From: Tristen Spear <tspear@clinellc.com>
Sent: Thursday, February 16, 2023 2:46 PM
To: CSC-DL Siting Council <Siting.Council@ct.gov>
Cc: David Ford <dford@clinellc.com>
Subject: RE: 1825 South Main St (EM-CING-083-220517)

Please see the attached as built CDs and sector overview photos. Only 3 antennas were installed per sector as opposed to the originally proposed 4 antennas per sector.

SITE NAME: MIDDLETOWN SO MAIN

**PROJECT: 5G NR 1DR-1 LTE 3C 5G NR RADIO, 5G NR 1SR CBAND, 4TX4RX
SOFTWARE RETRO, 2022 UPGRADE**

AT&T
★ ANTENNA LAYOUT PLANS & ELEVATION
5G NR 1DR-1 LTE 3C 5G NR RADIO, 5G NR 1SR CBAND, 4TX4RX SOFTWARE RETRO

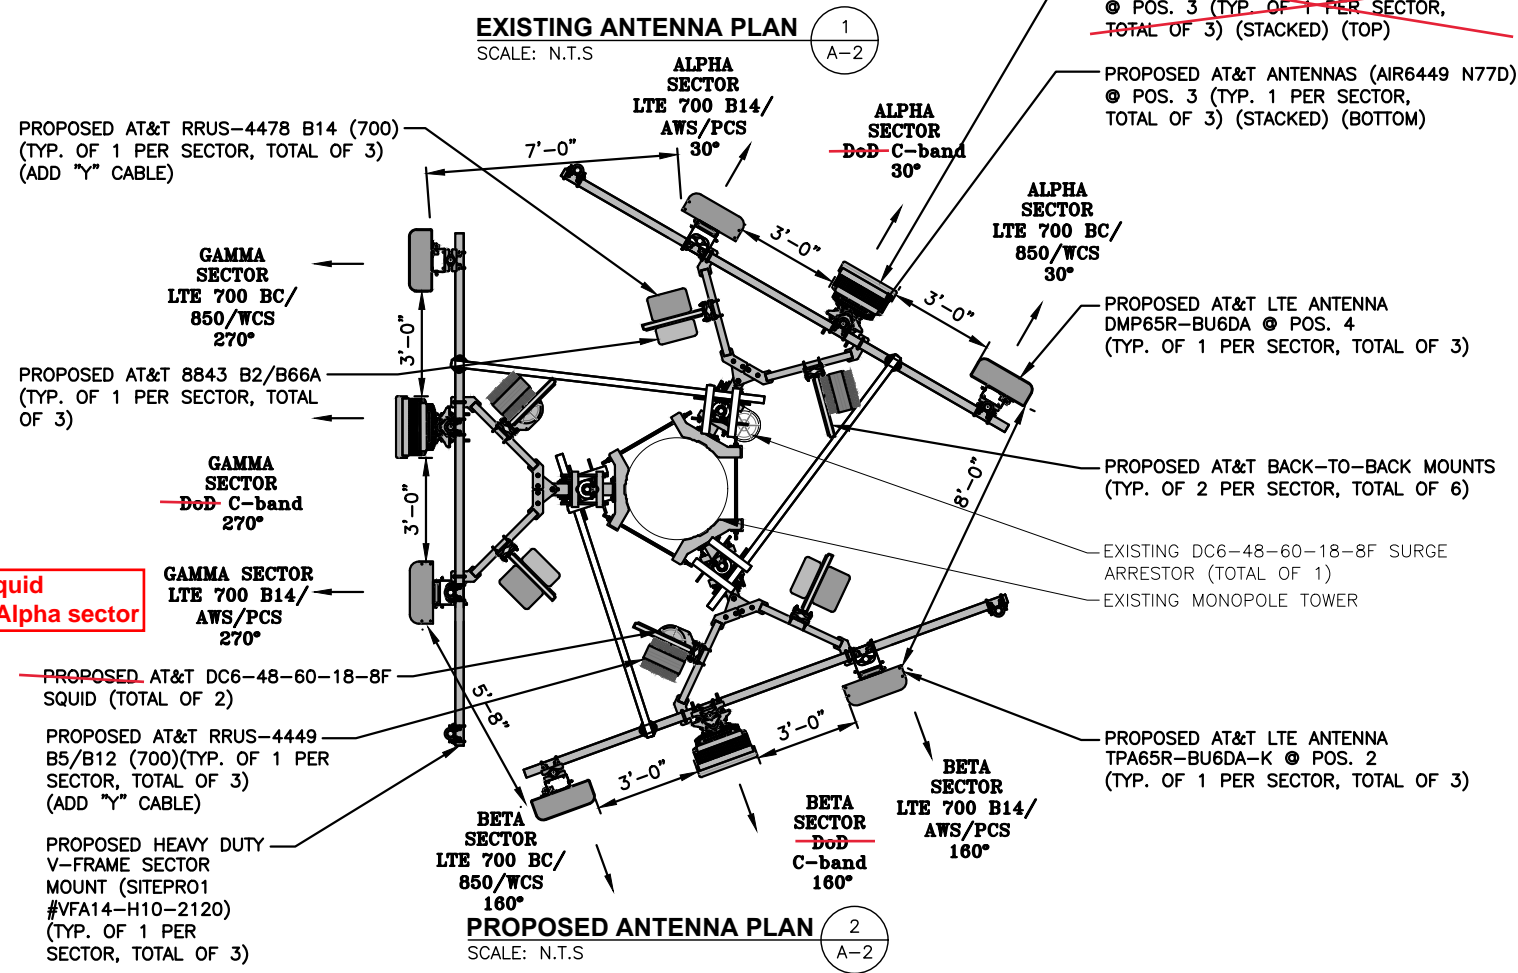
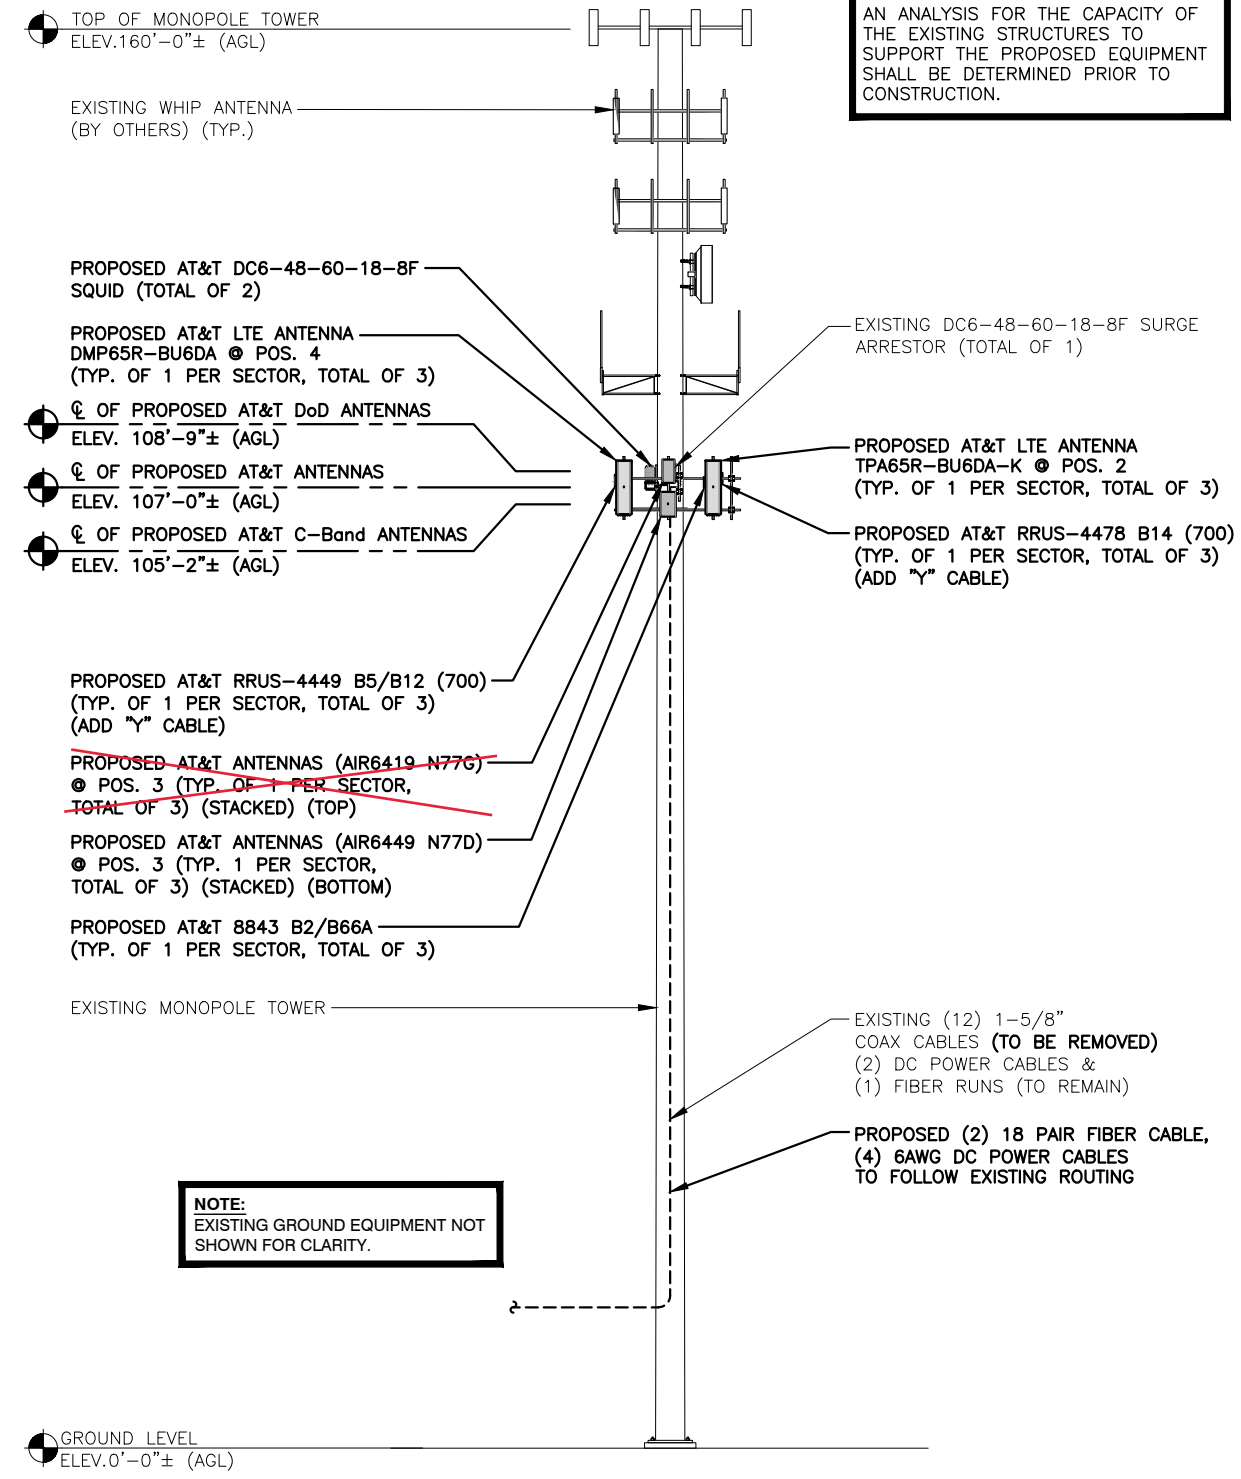
Redlined - A2, A3
Centerline Communications
Tristen Spear
12/15/22 10:26 AM

Proposed squid installed in Alpha sector

AT&T DETAILS
5G NR 1DR-1 LTE 3C 5G NR RADIO, 5G NR 1SR CBAND, 4TX4RX SOFTWARE RETRO
SITE NUMBER: CTL01208
DRAWING NUMBER: A-3
REV: 1

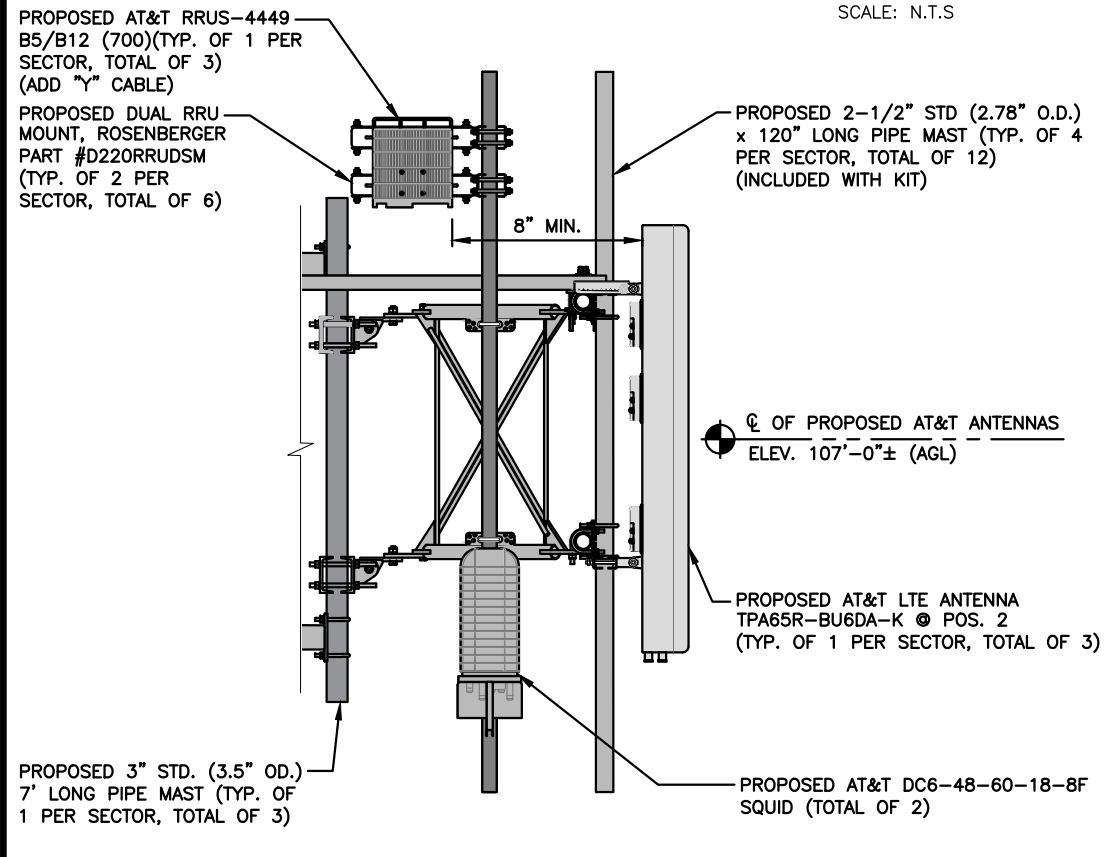
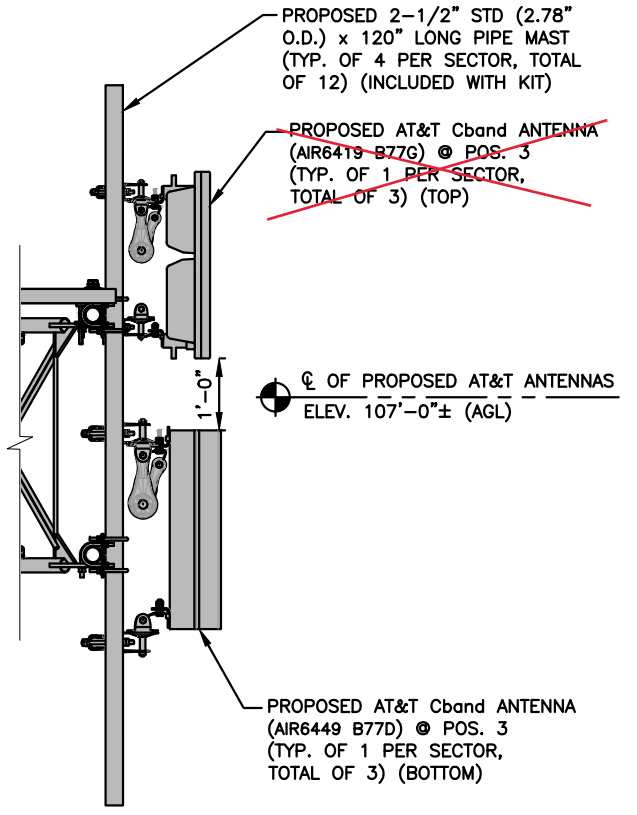
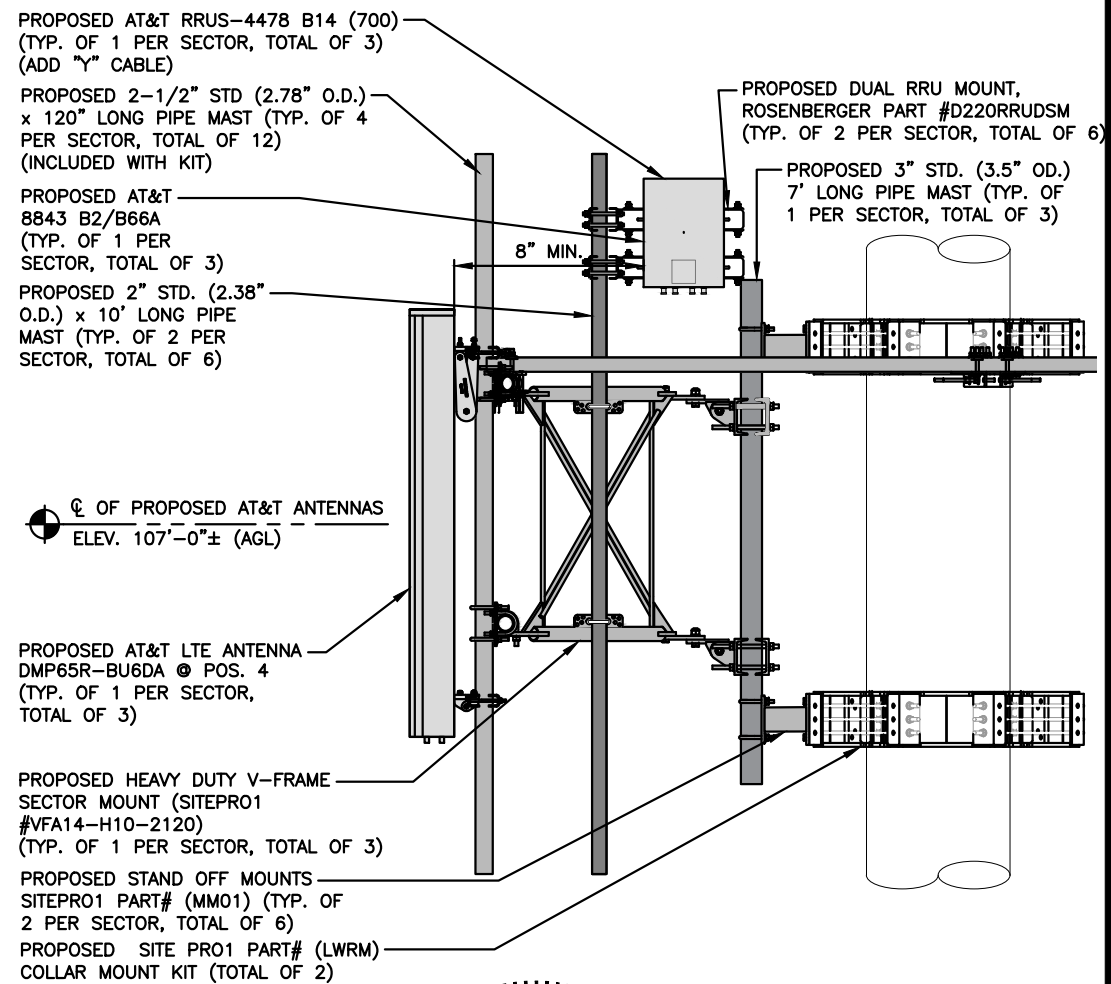
Redlined - A2, A3
Centerline Communications
Tristen Spear
12/15/22 10:26 AM
